10-2016 LATEST REVISION DATE	APPROVED BY BRIDGE ENGINEER	STANDARD DESIGN - 40' ROADWAY, 3 SPAN BRIDGES ROLLED STEEL BEAM BRIDGES JUNE, 2010
FRAMING PLAN 180'-0" BRIDGE		RS40-043-10

0° SKEW FRAMING PLAN

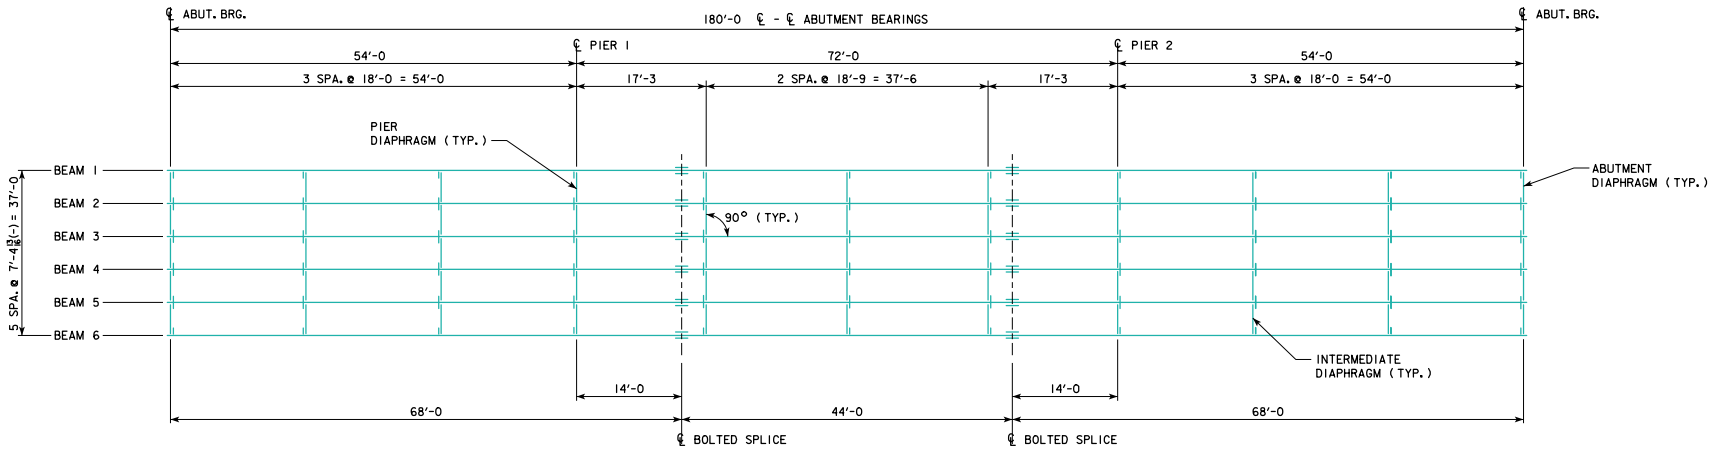
REVISED 10-2016 - CHANGED DIAPHRAGM SPACING IN ZERO SKEW FRAMING PLAN (WAS 4 SPACED AT 18'-0") IN 72'-0" CENTER SPAN. CHANGED DIAPHRAGM SPACING IN SKEWED FRAMING PLAN (WAS 4 SPACED AT 18'-0") IN 72'-0" CENTER SPAN. ADDED DIAPHRAGMS TO SKEWED FRAMING PLAN IN OUTER BAYS, BETWEEN BEAMS 1 & 2 AND 5 & 6 OF 72'-0" CENTER SPAN, 9'-0" FROM PIER CENTERLINES.
